Access Compliance Report Public Rights-of-Way (Curb Ramps)

Main Street: KEMPTON_LN Cross Street: BLAKEMORE_DR Location: N

ADA ID: RPRK211021144008 Ramp Type: Type 4 - Parallel Initial Pass/Fail: Fail Overall Compliance: No Severity Score: 32

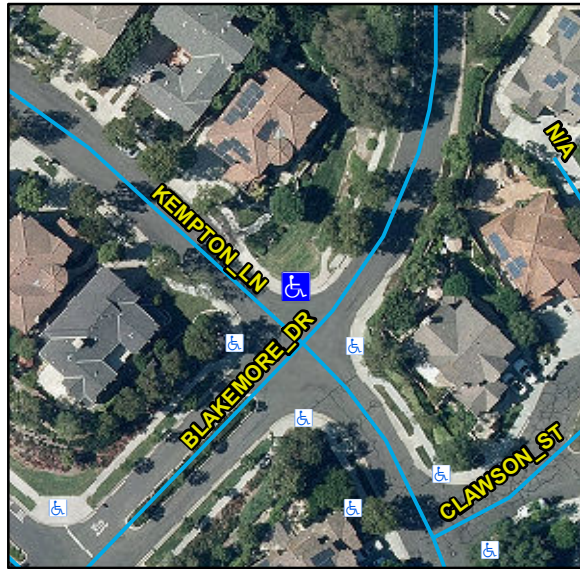
R204.3, R304.5.3, R304.3.2, STD 1115

Remove & Replace Curb Ramp With Two New Directional Ramps or Equivalent.
